September 21, 1973

SAFETY EVALUATION REPORT
BY THE
DIRECTORATE OF LICENSING
U.S. ATOMIC ENERGY COMMISSION
IN THE MATTER OF
CONSOLIDATED EDISON COMPANY OF NEW YORK, INC.
INDIAN POINT NUCLEAR GENERATING UNIT NO. 3
DOCKET NO. 50-286

FIGURE 6-4

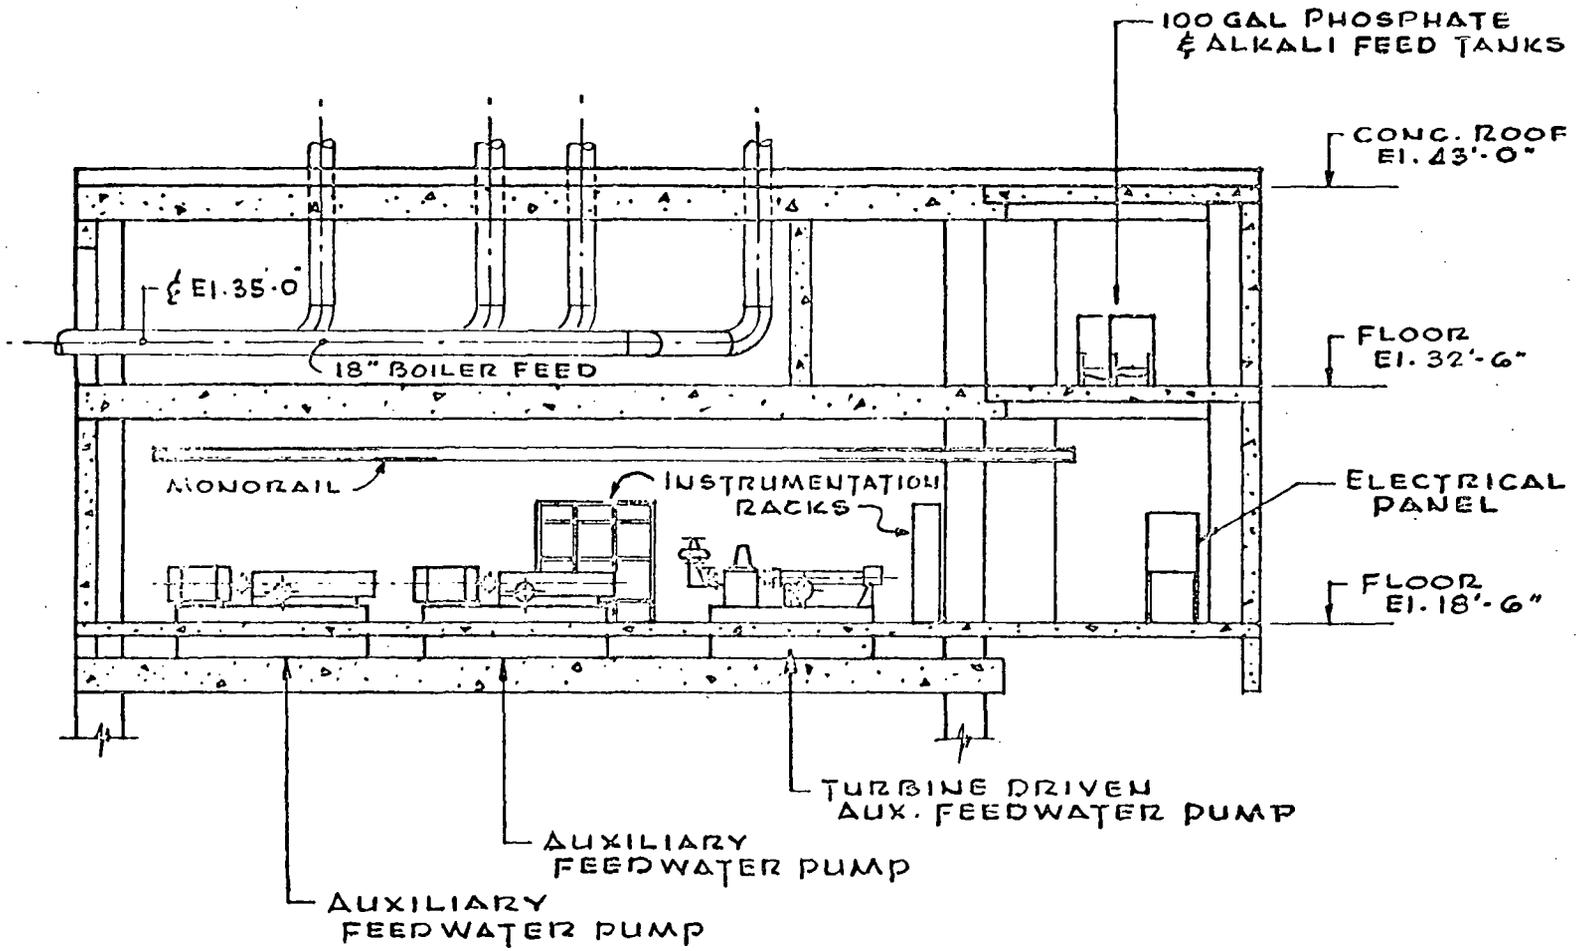
The auxiliary feedwater system removes heat from the secondary system whenever there is a loss of normal feedwater. Normal feedwater can be lost by pipe breaks, pump failures, valve malfunctions, or loss of offsite power. The auxiliary feedwater system also influences the fuel cladding peak temperature following a small break in the primary coolant system.

Auxiliary feedwater is supplied by two motor-driven auxiliary feedwater pumps and one steam turbine-driven auxiliary pump. Each motor-driven pump will deliver 400 gpm (at a head of 3200 feet) and the

steam turbine-driven pump will supply 800 gpm (at a head of 3300 feet).

FIGURE 10.1
ELEVATION VIEW
SHIELD WALL REGION

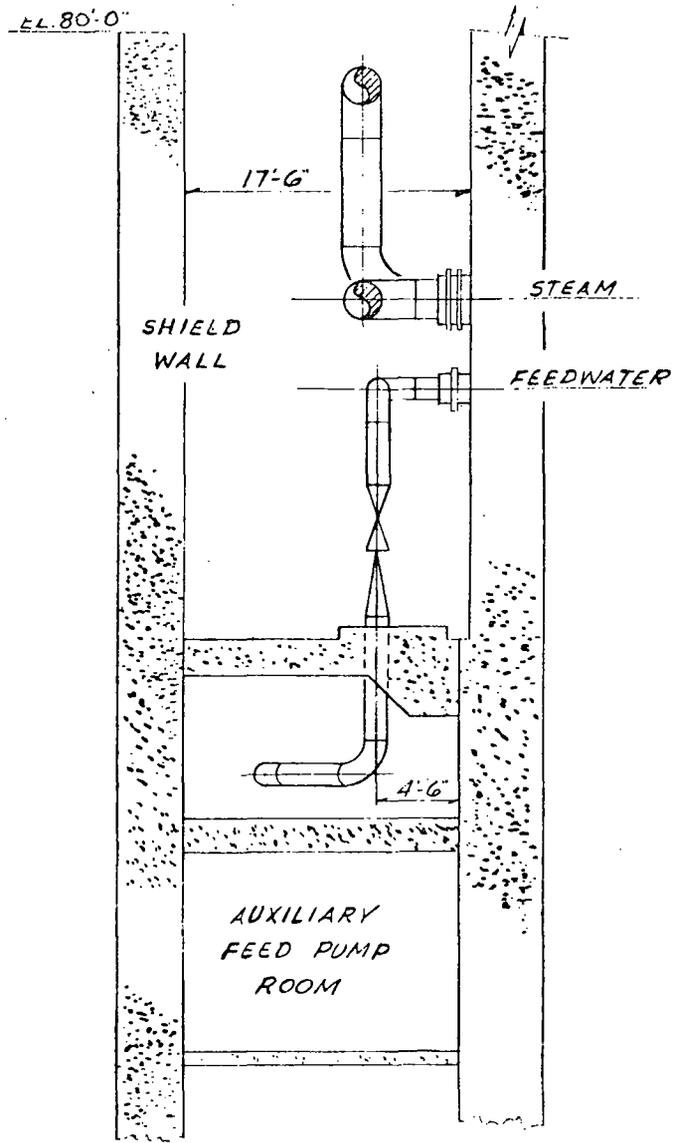
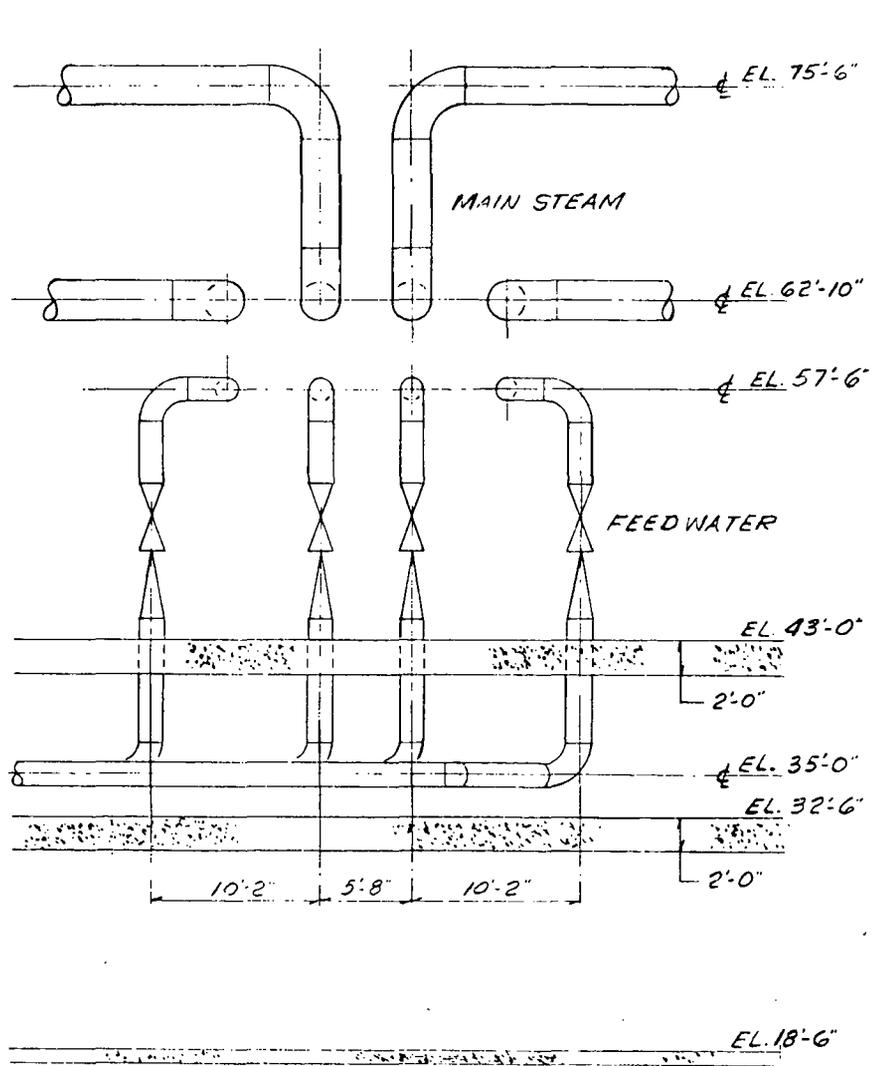
The possible effects of pipe whip, impingement, or high pressure and temperatures resulting from a postulated failure of any of the smaller high energy lines were investigated for the Control Building, the Diesel Generator Building, the Fuel Storage Building, the Turbine Building, and the Primary Auxiliary Building (PAB). Only the PAB required design modifications. The Control Room has essentially no high energy lines and the Diesel Generator Building's only high energy lines are the starting air lines whose failure would not damage Class I equipment. The Fuel Storage Building contains some auxiliary steam lines whose failure would not result in damage to the spent fuel pit. Failures of steam or feedwater lines within the Turbine Building will not prevent safe shutdown and will not cause the destruction of this large, highly ventilated building. Approximately 75 feet separate the nearest high energy line in the Turbine Building and the Control Building. This distance eliminates any concern about pipe whip and jet effects were found to produce negligible loads on the Control Building.

Design modifications that have been required as a result of the review of the smaller high energy lines include the addition of pipe restraints to portions of the steam generator blowdown lines, shielding around cable trays to eliminate jet impingement effects and an alarm system to prevent overheating of the penetration area because of a ruptured letdown line, steam generator blowdown line,

FIGURE 11-1

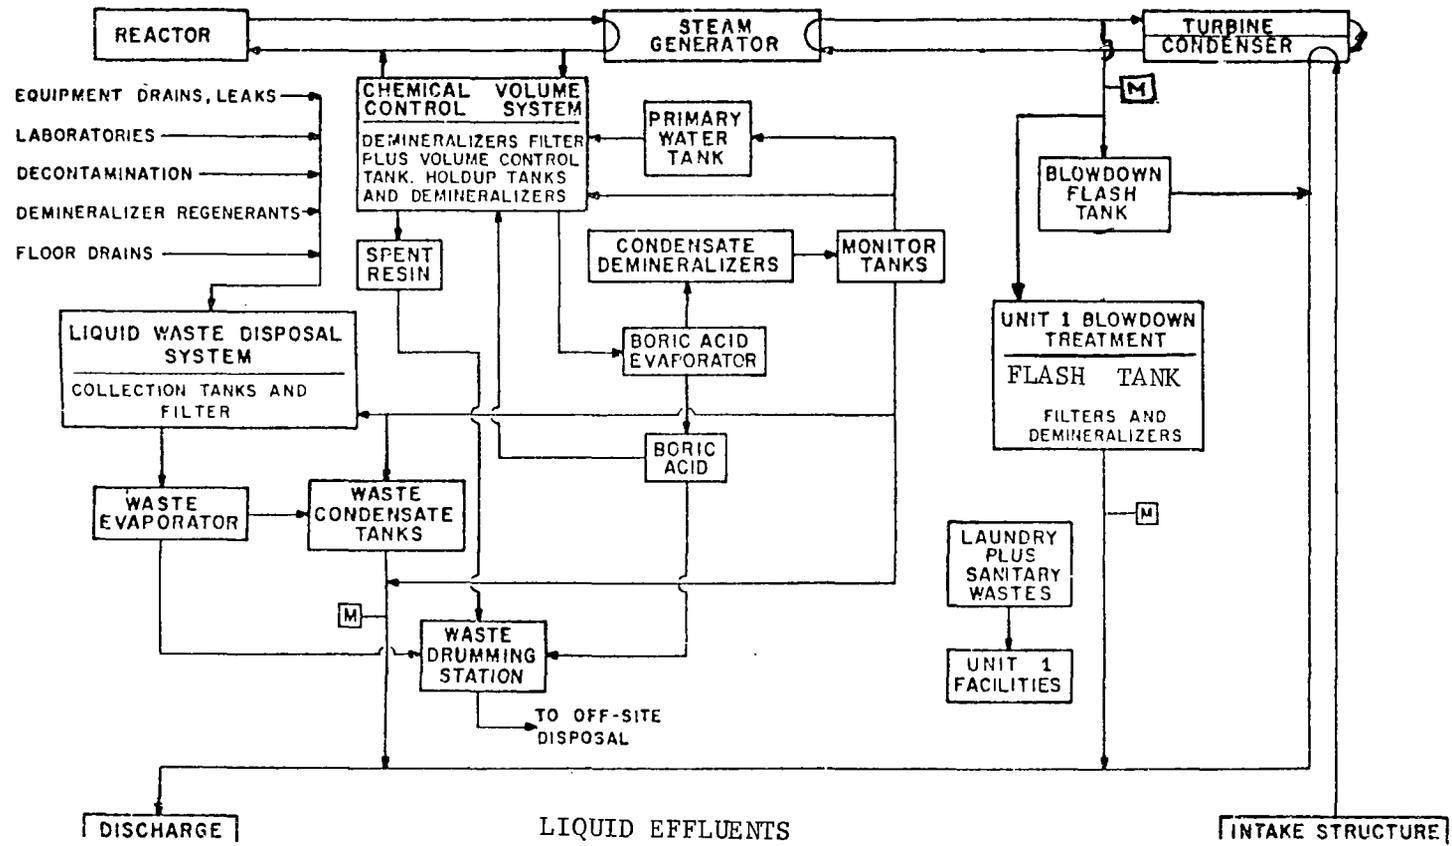
The total radioactivity in the liquid effluent released from Indian Point 3 to the environment was estimated by the applicant to be 9.6 Ci/yr, excluding tritium and 610 Ci/yr of tritium. Based on our evaluation, we calculate an annual release of radioactive material in the liquid effluent will be approximately 3.8 Ci/yr excluding tritium and 350 Ci/yr of tritium.

In our evaluation we calculated the radiation doses to an individual in unrestricted areas from the aquatic food chain and

swimming would be less than 5 mrem to the whole body and less than 5 mrem to the thyroid. Our radiation dose calculations considered the combined operations of Units 1, 2 and 3 at the Indian Point site. All radioactive liquid wastes will be continuously monitored before discharge. Assuming a circulating water flow rate at Indian Point 1 of 320,000 gpm and at Indian Point 2 and 3 of 870,000 gpm the radioactivity concentration released to the Hudson River will be less than 1% of the limits specified in 10 CFR Part 20.

FIGURE 11-2

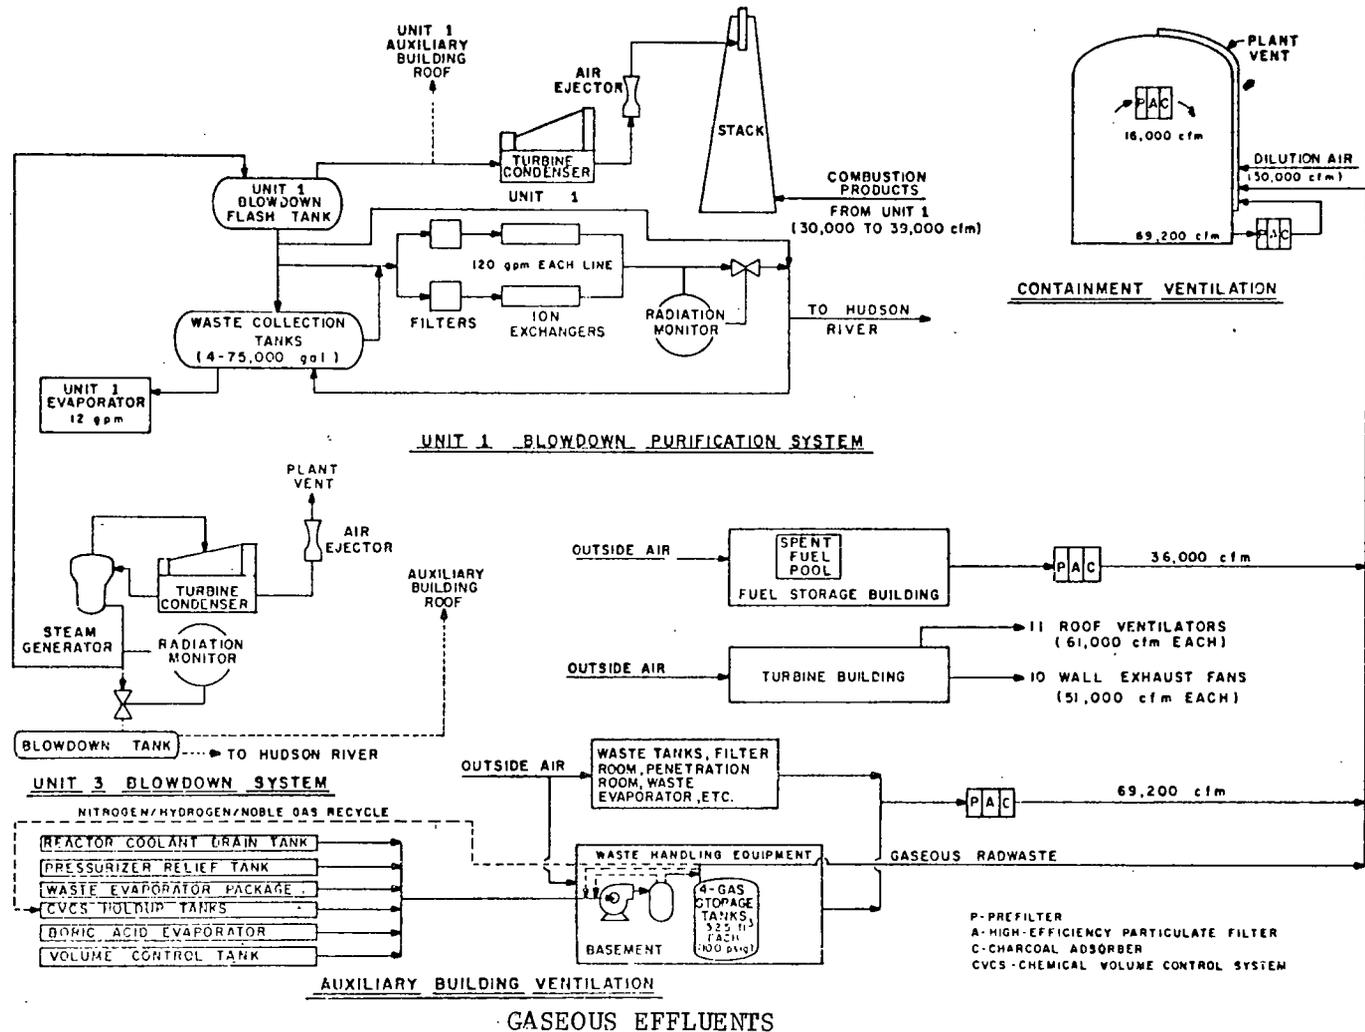
The applicant has estimated the radioactivity in the gaseous effluents released from Indian Point 3 will be 5500 Ci/yr of noble gases and 0.16 Ci/yr of iodine-131. For the combined operation of Indian Point 1, 2 and 3, the applicant's estimated releases are 11,000 Ci/yr of noble gases and 0.32 Ci/yr of iodine-131. The applicant also estimated that radiation doses to an individual at or beyond the site boundary from the combined operation will be 2.4 mrem/yr to the whole body and 1.4 mrem/yr to the thyroid from inhalation.

Based on our evaluation of the gaseous waste systems, we calculated that the radioactivity released from Indian Point 3 during normal operation will be 2700 Ci/yr of noble gases and 0.41 Ci/yr of iodine-131. For the combined operation of Indian Point 1, 2, and 3 we calculated the radioactivity release will be 6600 Ci/yr of noble gases and 0.88 Ci/yr of iodine-131. Based on the combined operation of Indian Point 1, 2 and 3 we calculated the annual average radiation doses at the site boundary will be less than 5 mrem to the whole body and less than 5 mrem to the thyroid from inhalation. We calculated that the radiation dose to a child's thyroid will be less than 15 mrem per year based on the grass-cow-milk pathway for radioiodine for the nearest actual cow, seven miles south of the site. The dose calculations were
